Midway City Council
7 December 2021
Regular Meeting

Mill Canyon Farms Subdivision /
Final Approval

CITY COUNCIL MEETING STAFF REPORT

Subject: Mill Canyon Farms – Final Review

250 WEST ROAD IMPROVEMENTS

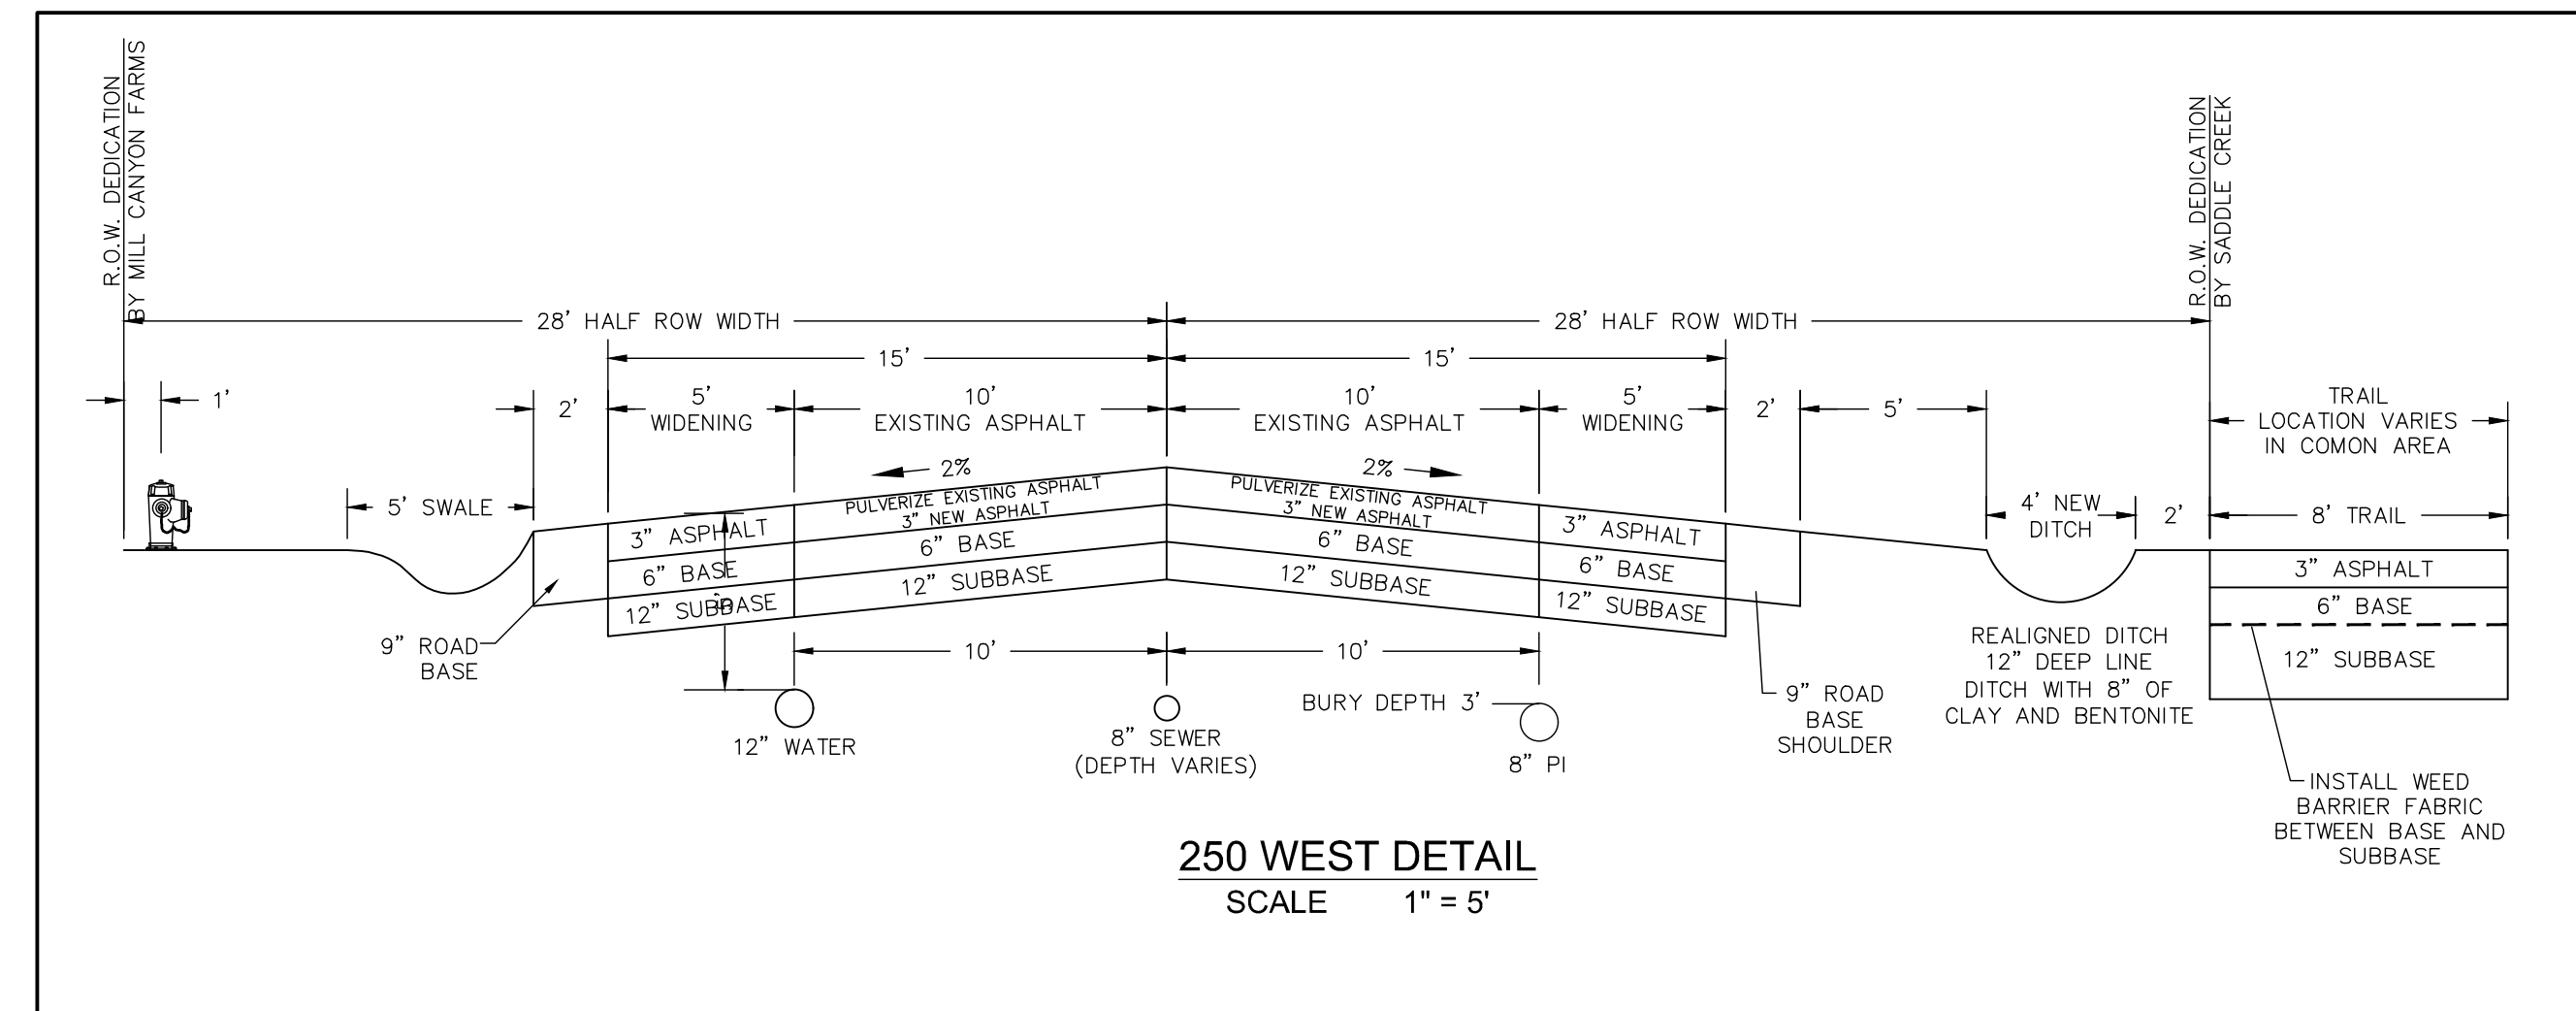
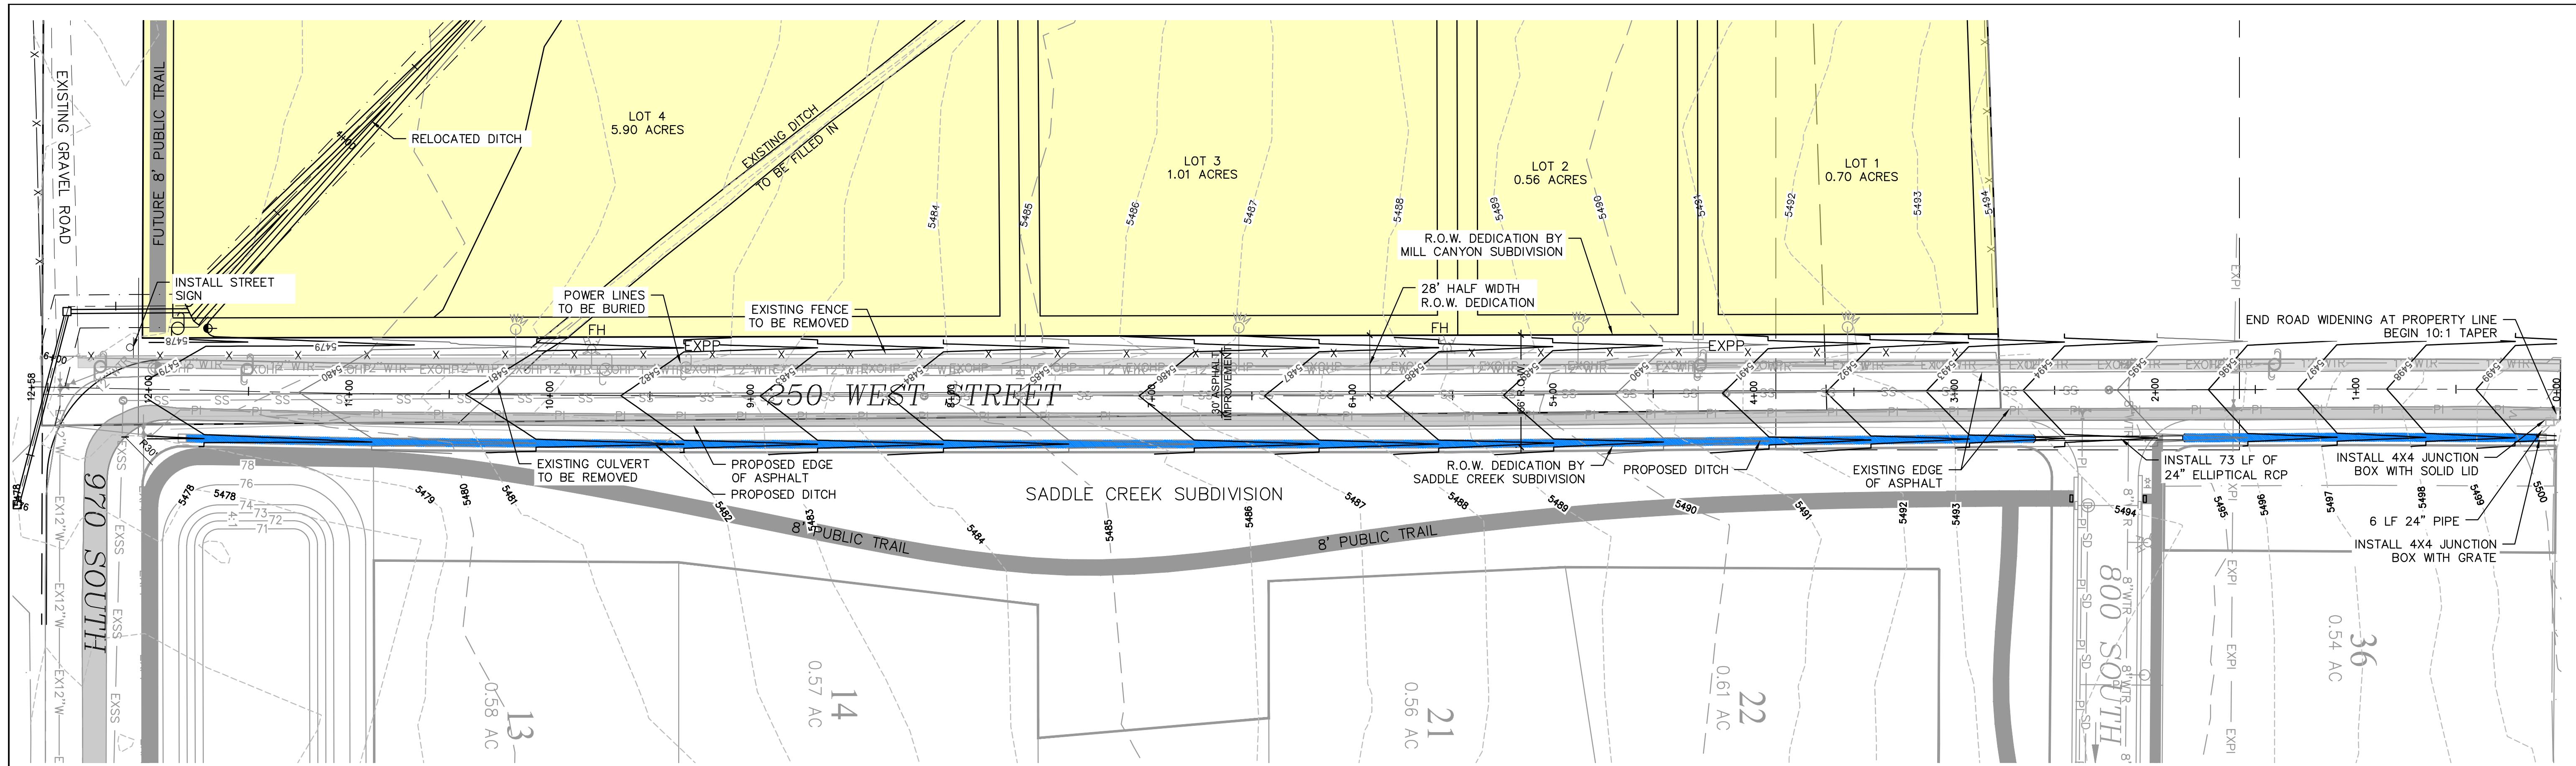
- The west side of 250 west will be rebuilt and widened to a half width and will be built in conjunction with the east side, which will be constructed as part of Saddle Creek development.
- The development will dedicate R.O.W for a future road to extend 970 South from 250 West to Stringtown Road and along 250 West.

- The proposed swale along the west side of 250 West will accommodate any storm drainage from the widening of 250 West and this development.

**PROPOSED DITCH RELOCATION
PLAN & PROFILE**

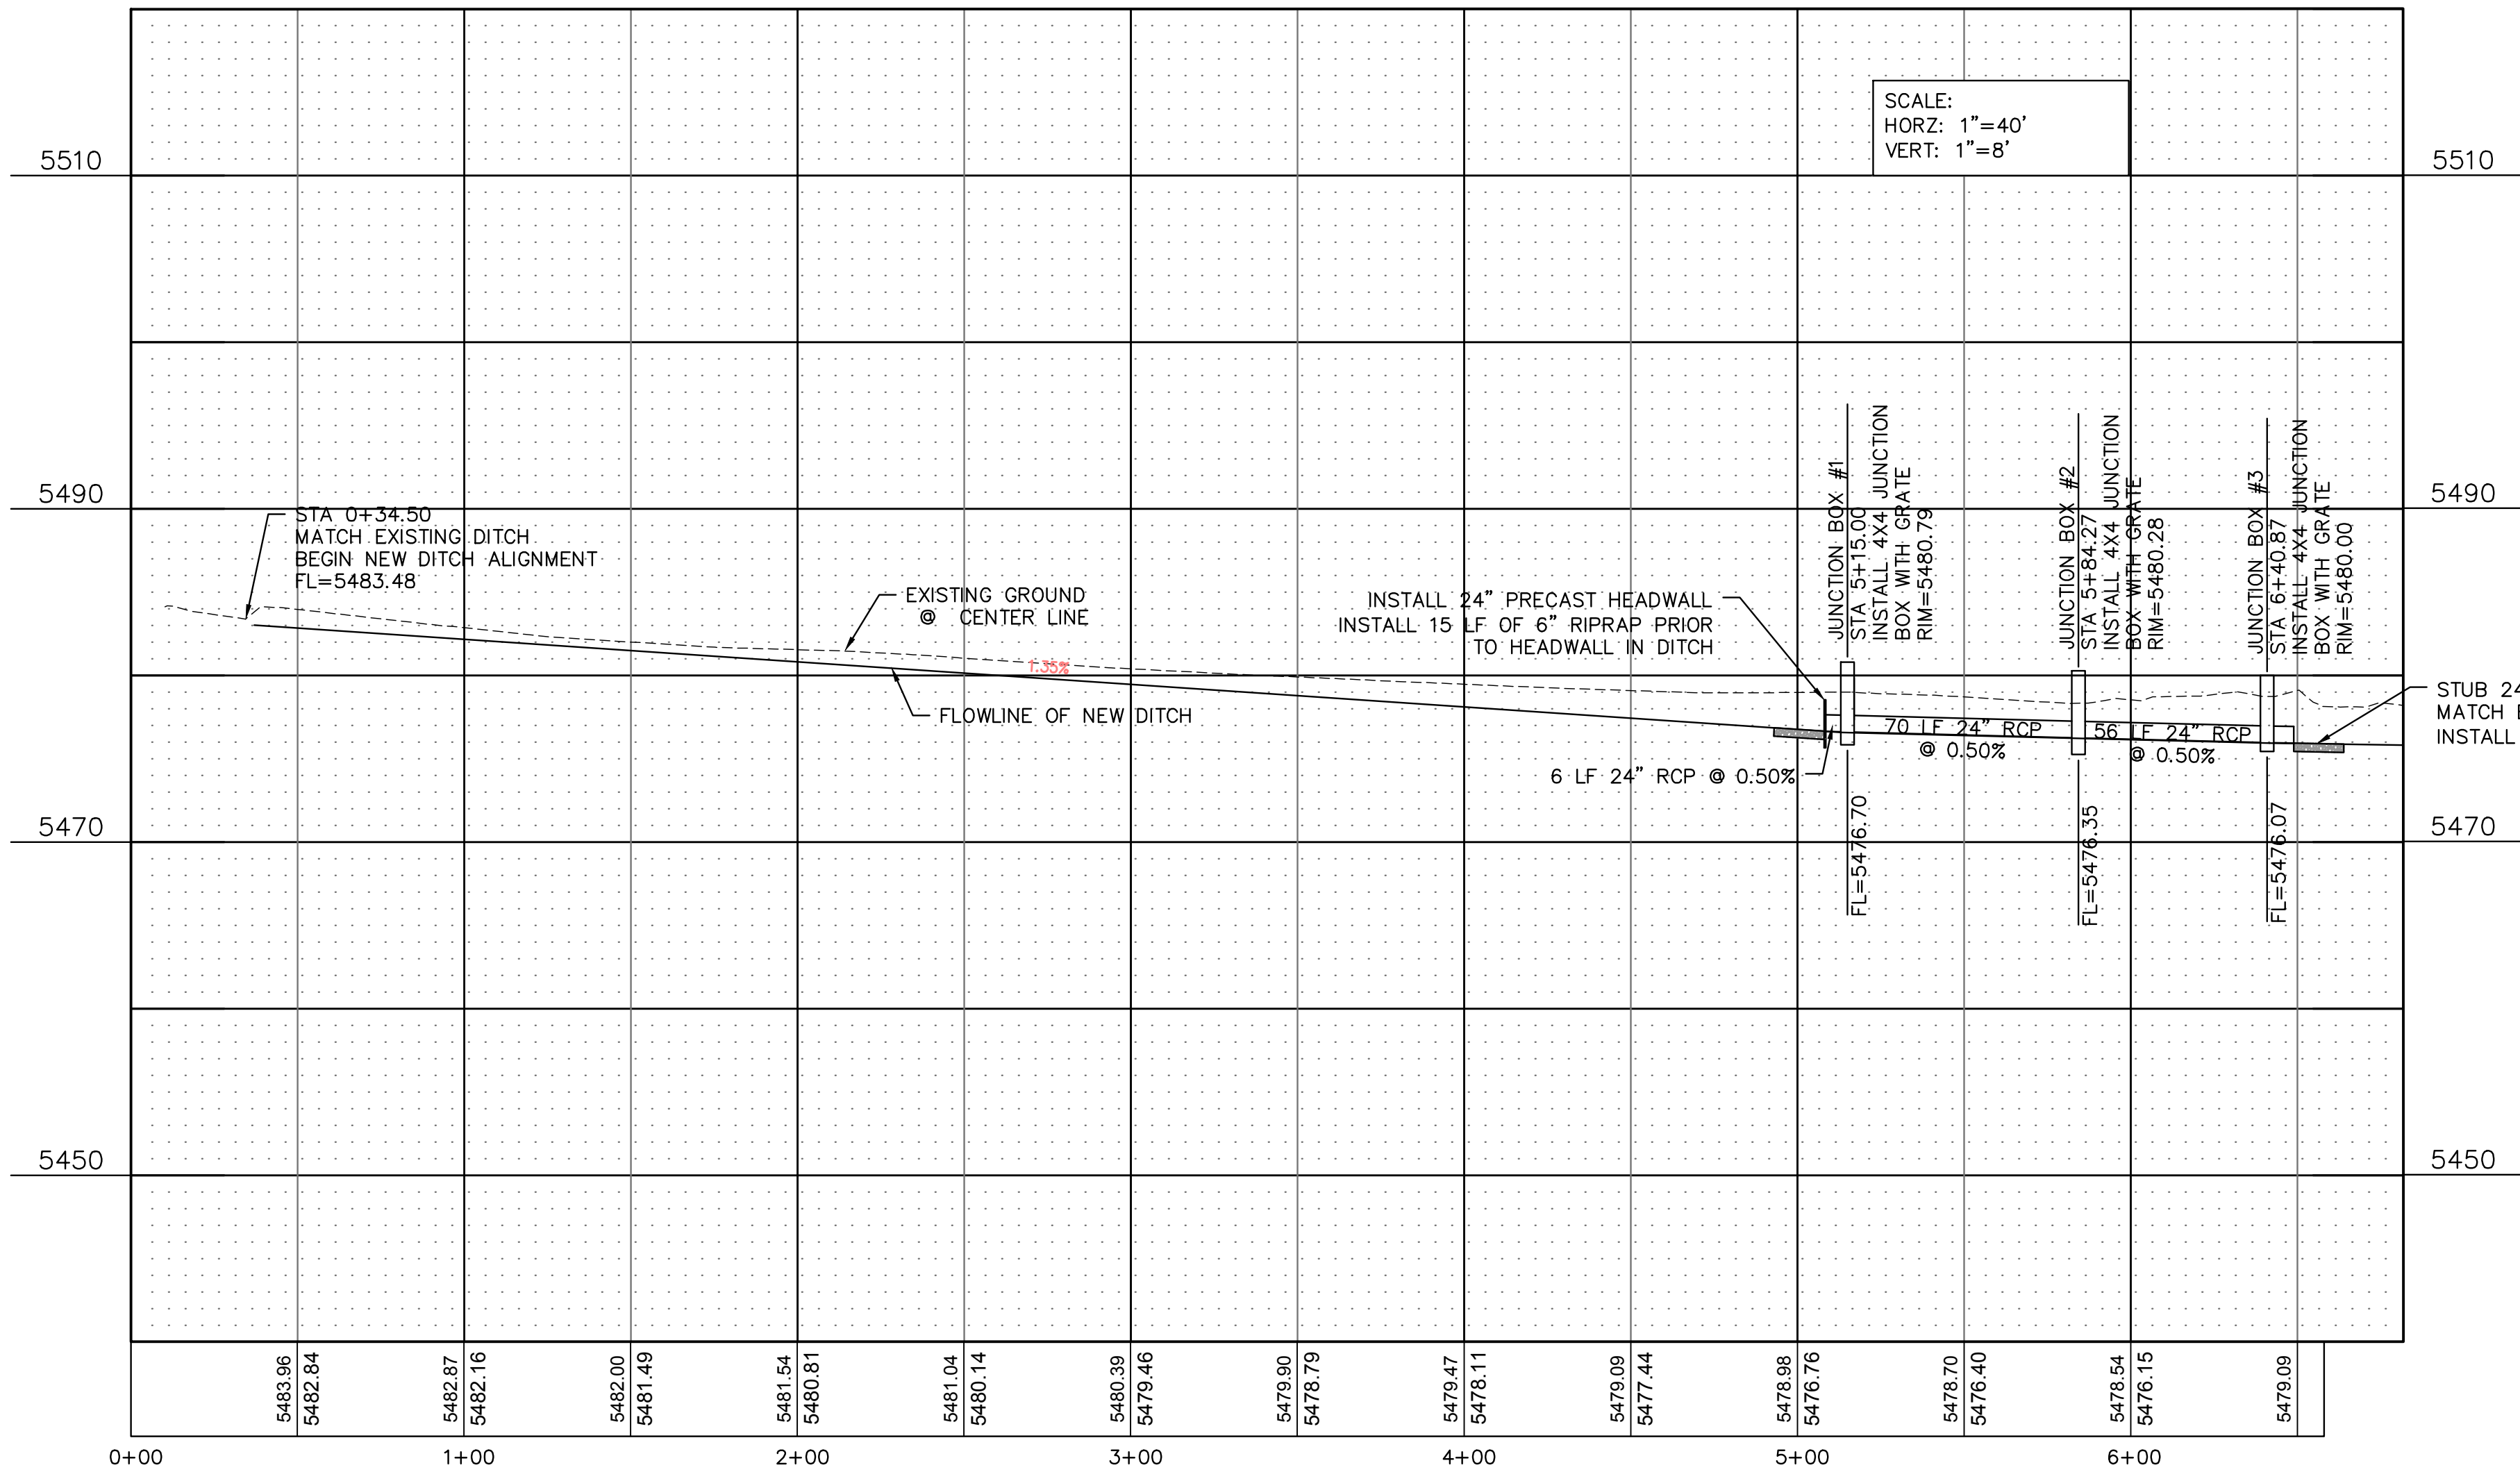
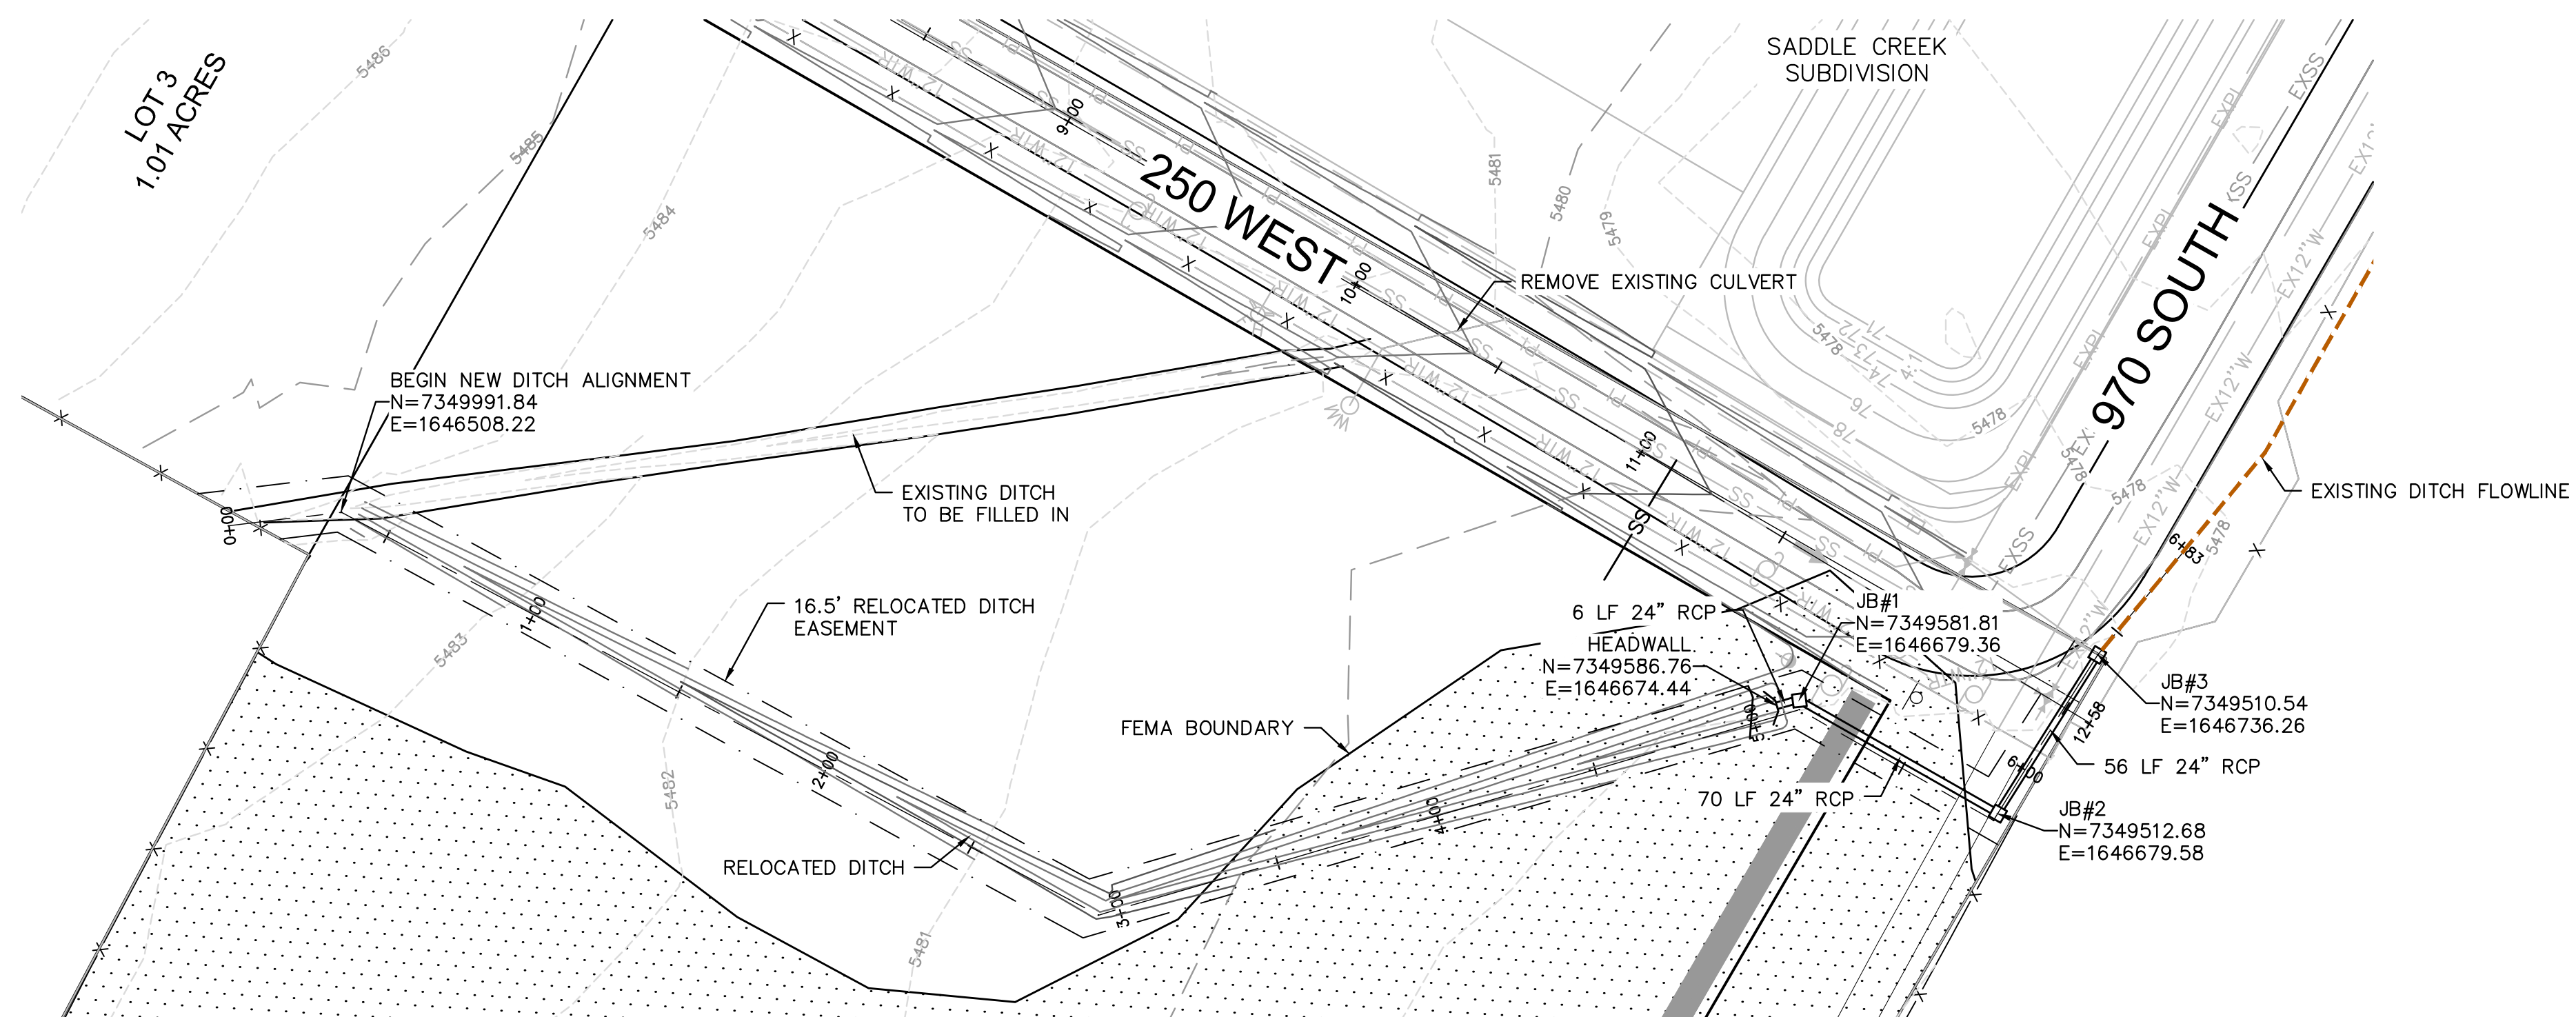
The applicant is also proposing that they reroute the ditch within lot 4 so that it creates less of an impact on the buildable area of the lot. The new ditch easement needs to be shown on the plat. If there are any existing easements, these should be released previous the plat being recorded.

- The development will be serviced by Midway Irrigation Company.
- The development will relocate an existing irrigation ditch in lot 4 and will need to pipe it to the existing ditch in the intersection of 970 South and 250 West.
